3.0 DESIGN OF STRUCTURES, COMPONENTS, EQUIPMENT, AND SYSTEMS

Section 3.1 of the Turkey Point Units 6 and 7 Combined License (COL) Final Safety Analysis Report (FSAR), Revision 8, incorporates by reference Section 3.1, "Conformance with NRC General Design Criteria," of Revision 19 of the AP1000 Design Control Document (DCD).

Section 3.2 of the Turkey Point Units 6 and 7 COL FSAR, Revision 8, incorporates by reference Section 3.2 of the AP1000 DCD, Revision 19. Section 3.2 of the DCD includes Section 3.2.1.

Figure 3-1 Comparison of applicant's horizontal FIRS with staff FIRS
Also shown are AP1000 CSDRS and the RG 1.60 spectrum anchored at 0.1g.

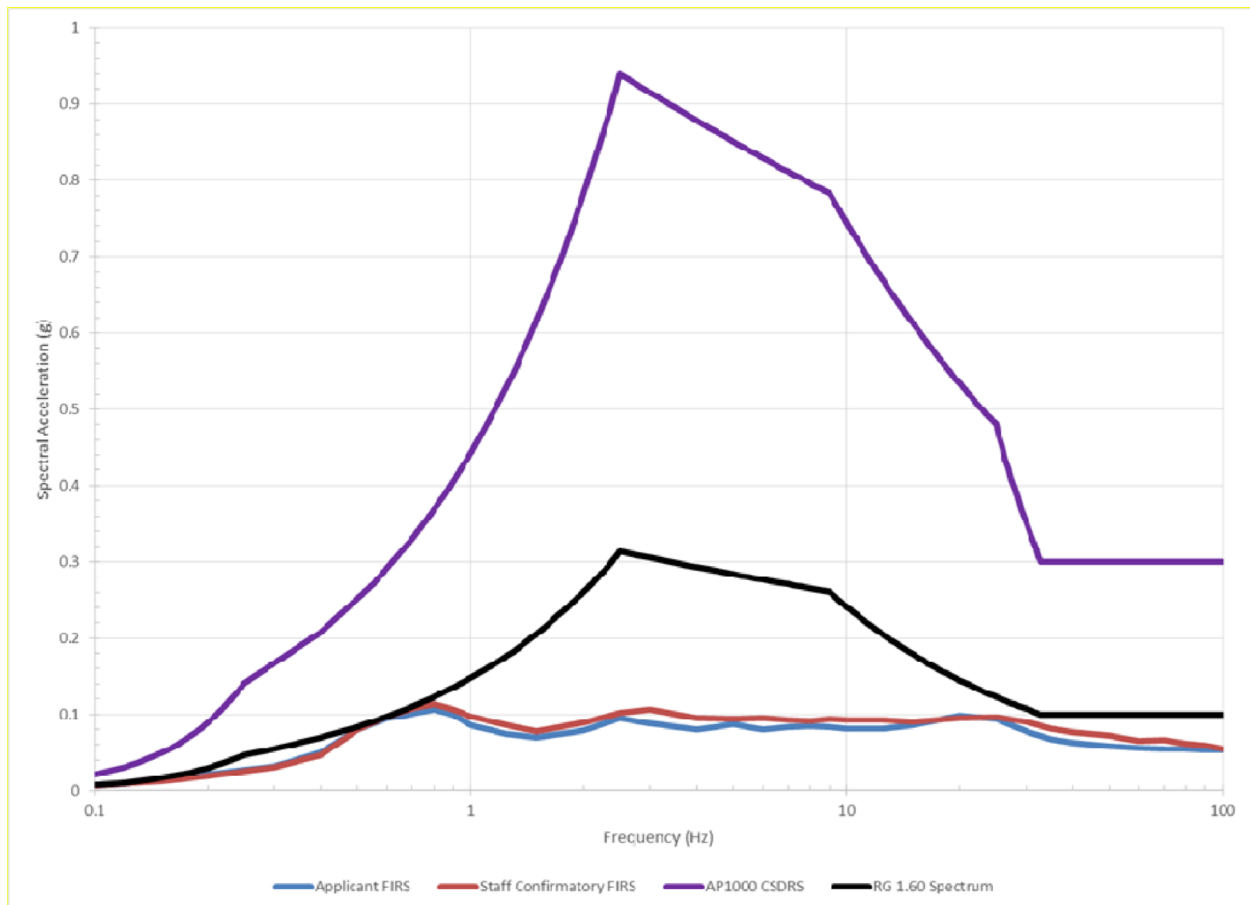
The staff used only the site profile developed for the NI along with the same input response spectra used by the applicant. The staff used only the profile for the NI because the site response for NI structures can reasonably be expected to be consistent with the geologic profile located under the structures. However, the staff notes that the applicant's use of a NI and a FAR profile is conservative because the applicant considers the envelope of the two FIRS results to be the site FIRS. The applicant compared the FIRS at the base of the NI and at the AP1000 CSDRS at plant grade in Figure 3.7-202. The CSDRS for the AP1000 certified design is specified at plant grade. The staff notes that the horizontal design response spectra (DRS) at the surface (which is the same as the performance-based surface response spectrum (PBSRS) defined in ISG-017) shown in Figures 2.1-9 through 2.1-14 of Letter L-2015-085, Attachment 2, dated April 2, 2015, are significantly lower than the CSDRS which is also applied at the surface.

Figure 3-1 compares the applicant's FIRS result with that calculated by the staff, the AP1000 certified design response spectra, and the RG 1.60 response spectra anchored at 0.1g Turkey Point site-specific ground motion applied at the FIRS elevation in the SSI analyses. Overall, the FIRS results are similar, with minor differences attributable to differences in approach and randomization parameters.

The vertical FIRS is obtained by scaling the horizontal FIRS by vertical to horizontal (V/H) ratios from RG 1.60. The horizontal and vertical FIRS were compared to the AP1000 CSDRS and show that the CSDRS envelopes the FIRS. In RAI 4975, Question 03.07.01-12, the staff asked why V/H ratios selected were from RG 1.60 as opposed to V/H ratios from the generic database for the characteristic events associated with the site-specific PSHA.
